Re: DA-2023 / 113
Project : PROPOSED DWELLING AND
RESTROSPECTIVE APPROVAL OF
OUTBUILDING AND GROUND-BASED
SOLAR ARRAY

281 SNUG TIERS ROAD, SNUG, TAS

In response to council's first RFI of 2/10/23 regarding the above, and later RFI's of 8/5/25 and 29/5/25, I submit the following, addressing all items as follows, **with responses in red:**

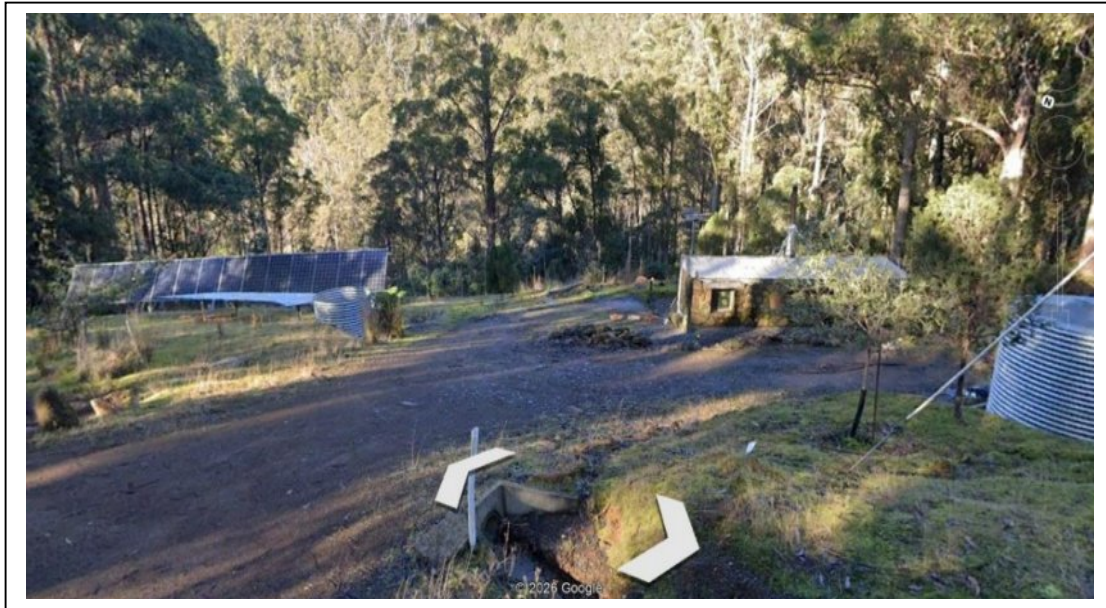
Clause E14.7.1: If the responses to Items 3 and 5 confirm the extent of native vegetation removal exceeds 500m², please provide sufficient documentation to demonstrate how the proposal will satisfy Performance Criterion P1:

The amount of vegetation that requires clearing to create a BAL-29 BHMA, as shown on DWG-02 / C, is approximately 650m², with an area to the eastern side of the BHMA of approximately 400m² and an area to the southern side of the BHMA of 250m.

The effect on the skylight of the removal of trees 4 – 19 will result in only negligible change to the silhouette of skylines to the south viewed from Snug Tiers Road; and maintain scenic landscape value.
